## MILPITAS PLANNING COMMISSION AGENDA REPORT

**TITLE:** **SITE AND ARCHTECTURAL APPROVAL AMENDMENT  
NO. SA2004-123**

**Proposal:** A request to permit five (5) accessory structures, site lighting and a perimeter property fence for a hillside residence.

**Location:** 1594 Pebble Beach Court (APN:029-55-018)

**FENCE DETAIL: OPEN TYPE EXISTING**

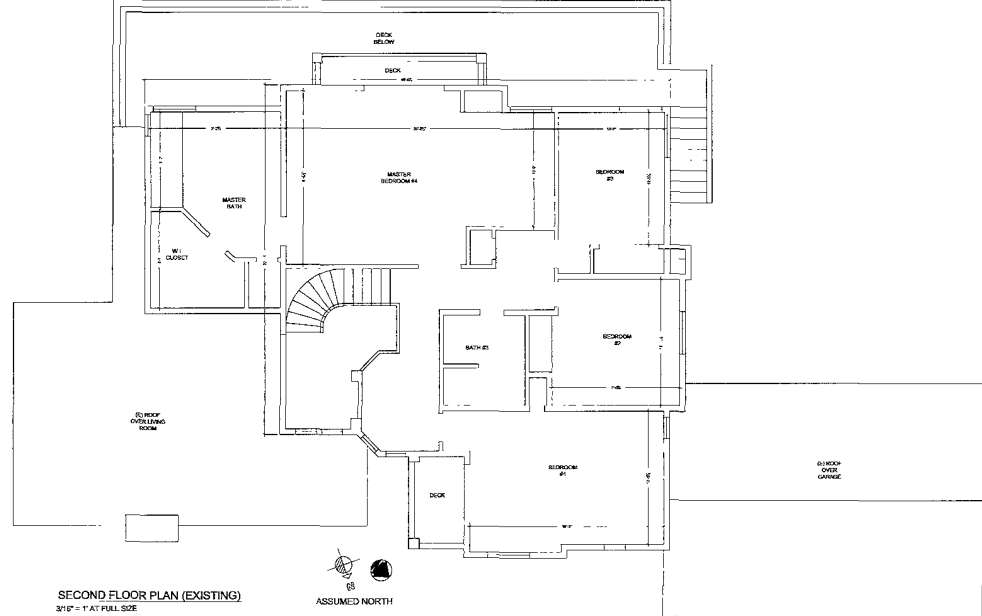
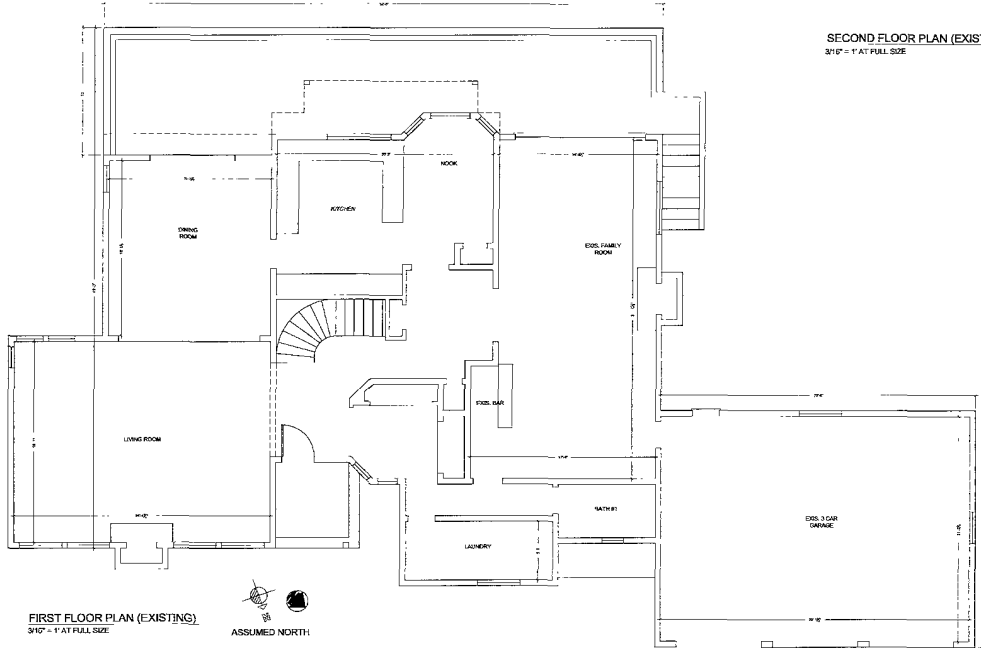
The existing and proposed modifications to the perimeter fence are in conformance with zoning ordinance with the exception of material. Pursuant to Section 54.11-5 all fence posts and supporting framework must be wood in order to maintain the rural character of the hillside. However, as noted in this section, the Planning Commission may approve an alternative material for the posts. The existing posts and retaining wall bases are comprised of concrete and painted white. The use of the concrete allows the base to act as a retaining wall, which connects the post of the same material. The base and posts complement the residence and similar material used within the rear yard. Similar fence types have been approved within PUD 21 and therefore staff concludes it would be appropriate and not be out of character within the hillside development.
